***EXHIBIT E***

***Block Diagram***

Title	Optimize USB ADSL Modem
Scale	B
Document Number	Block diagram
Date	Thursday, February 17, 2000
Sheet	1 of 9
Rev	G

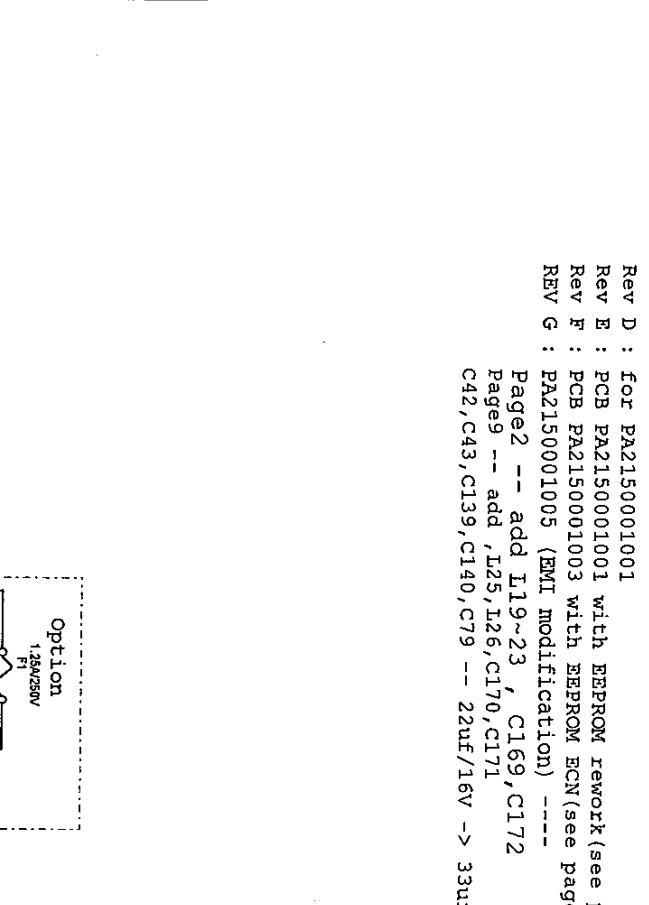
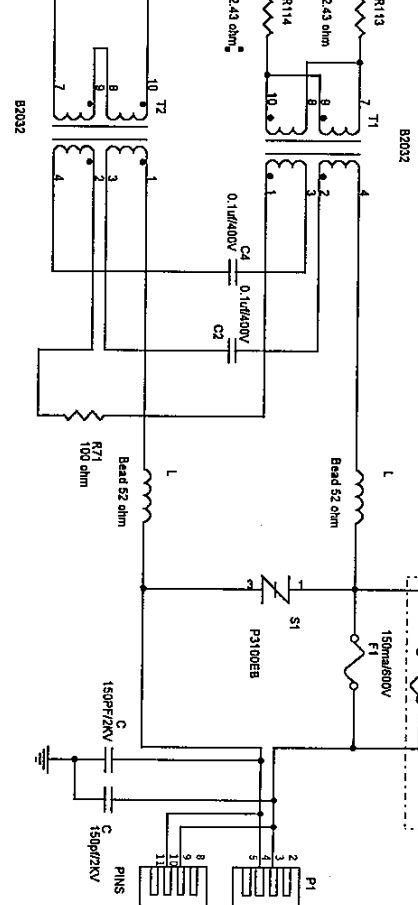
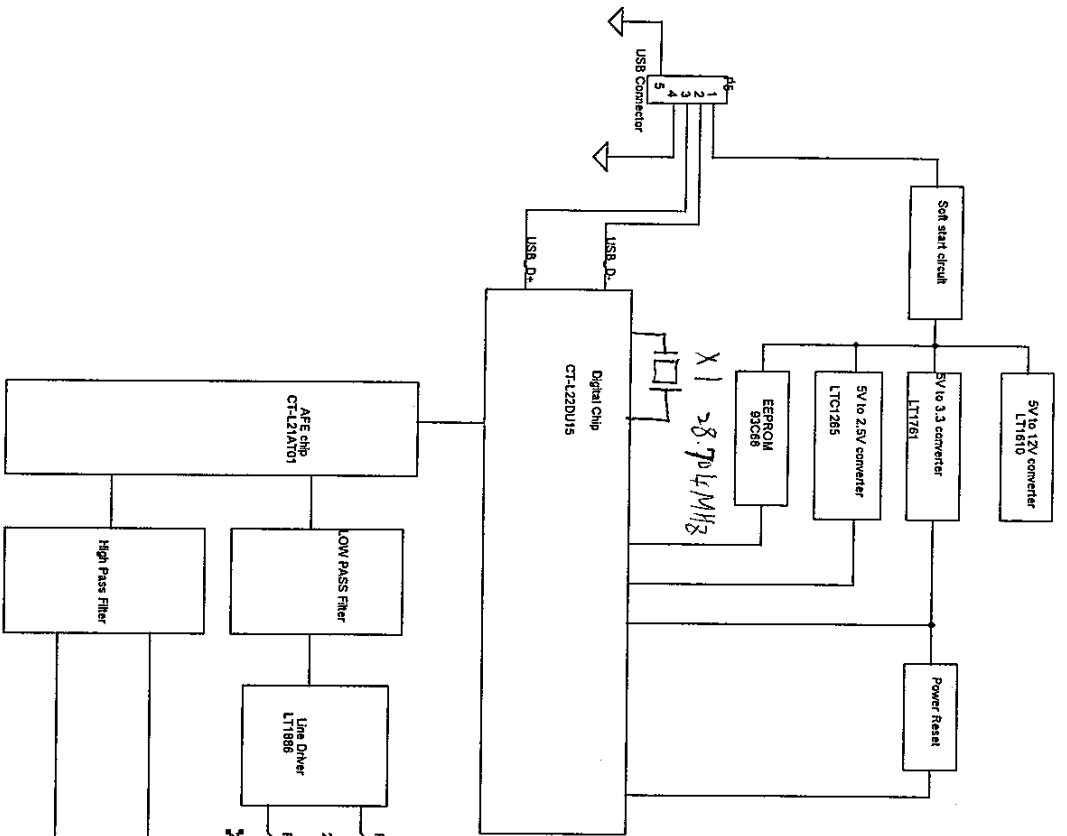
Rev D : For PA2150001001  
 Rev E : PCB PA2150001001 with EEPROM rework (see page 5)  
 Rev F : PCB PA2150001003 with EEPROM ECN (see page 5)  
 Rev G : PA2150001005 (EMI modification) ----  
 Page2 -- add I19~23 , C169, C172  
 Page9 -- add , L25, L26, C170, C171  
 C42, C43, C139, C140, C79 -- 22uF/16V -> 33uF/16V
